Wekiva Basin HSPF and HEC-RAS model preliminary review comments

George McMahon, Ph.D., PE, D.WRE, PH, Arcadis

October 19, 2018

Figure 1: Mean monthly precipitation for the 1914-2016 period of record (blue line) and the 2001-2016 HSPF model simulation period (red line)

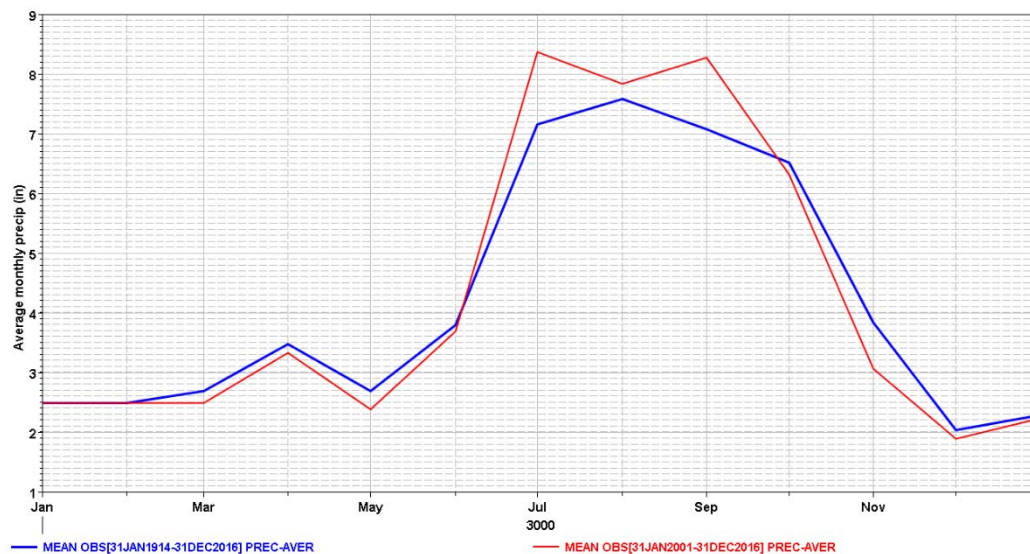
3. Statistical analysis of long-term mean aerial precipitation (MAP) data over the Wekiva Basin would be useful to identify where the simulation and calibration periods (2001-2016 and 2003-2012, respectively) rank in terms of long term climate cycles and hydrologic extremes. Figure 1 below shows wetter summers (June – September) on average during the 2001-2016 model simulation period (red line) than throughout the 1914-2016 precipitation record (blue line). Overall, average annual precipitation during the simulation period is also slightly higher (about 1.5%) than over the full period of record.
